**DOCKET****08-AFC-9****Hilarie Anderson - PHPP AQ ERC Issues**

**From:** Felicia Miller  
**To:** Docket Optical System  
**Date:** 8/16/2010 9:52 AM  
**Subject:** PHPP AQ ERC Issues

>>> Steve Radis <steve.radis@mrsenv.com> 8/12/2010 5:07 PM >>>  
 Felicia,

**APPLICATION FOR CERTIFICATION**  
**For the *PALMDALE HYBRID***  
***POWER PROJECT***

Figure 1. Location of PHPP Proposed Emission Reduction Credits

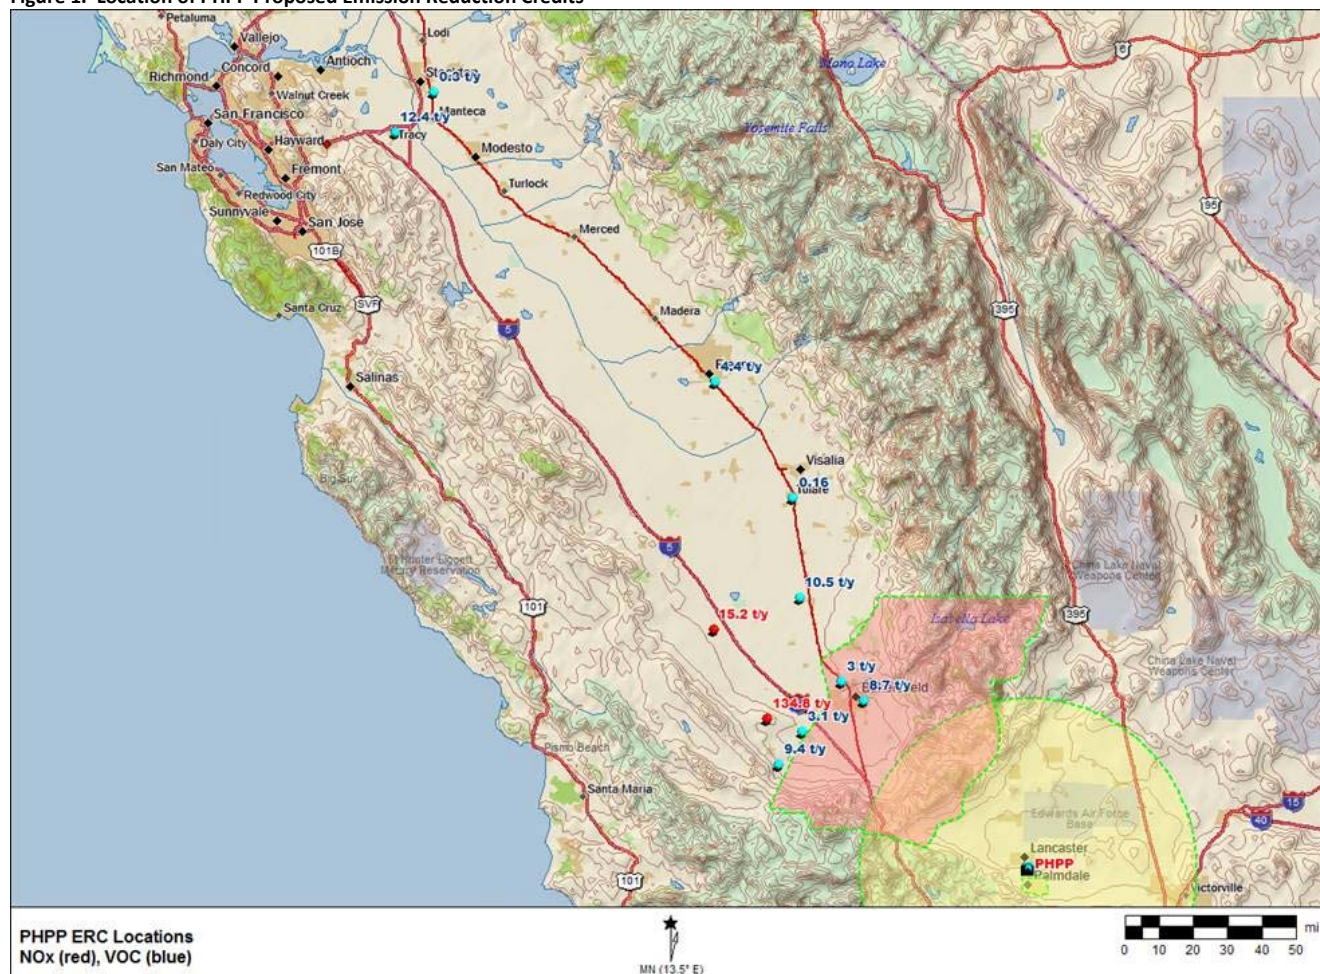
The map below (Figure 1) shows the location of the proposed PHPP ERCs for NOx and VOC. The swap for the ERCs in Stockton and Tracy would involve a trade between Calpine and a currently unknown party to swap for reduction sites in the southern part of the basin. The fact that all of the ERCs are from Calpine, and that there appears to be a need for Calpine to swap ERCs from Stockton and Tracy, would make one suppose that there is some sort of relationship between the applicant and Calpine. There are plenty of other ERCs out there that would avoid the need for Calpine to swap ERCs, but perhaps dealing with just one party simplifies the process for the City of Palmdale.

The yellow circle on the map represents a 50 mile radius around the PHPP, while the salmon colored area represents a 50 mile wide zone extending from the western boundary of the Mojave Desert Air Basin (MDAB). No ERCs have been identified within a 50 mile radius of the PHPP, while only two ERC sources are within 50 miles of the MDAB. However, the majority of the ERCs are not that much further beyond 50 miles from the MDAB, with the main NOx ERCs from Elk Hills about 89 miles from PHPP and 60 miles from the western MDAB boundary (see Table 1). The proposed ERCs all appear to have been properly banked from actual emission reductions. The ERCs were also discounted at the time they were banked in order to produce a net air quality benefit. The main concern that we have at this time is whether or not some of these ERCs are too far from the PHPP to offset project emissions and result in a net air quality benefit.

Figure 2. California Air Districts

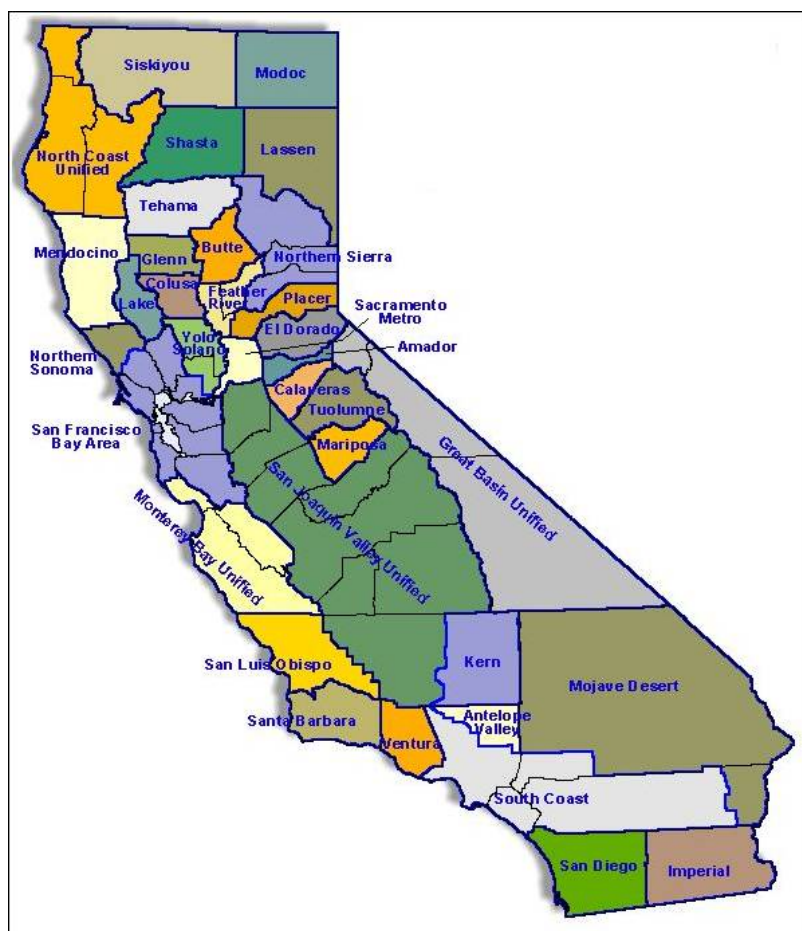
- **Should distance ratios be applied to the ERCs from the San Joaquin Valley?** Since the AVAQMD is very small (see Figure 2), no distance ratios were included in their rules. If the SJVUAPCD rules are used as guidance, many of the ERCs identified in the San Joaquin Valley would be questionable in terms of offsetting PHPP emissions and demonstrating a net air quality benefit. This is probably a decision best left to the ARB and USEPA prior to project licensing; however, per SJVAPCD Rule 2201 guidance, an offset ratio of 1.5:1 should be used at a minimum give the large distance between the PHPP and proposed ERCs.
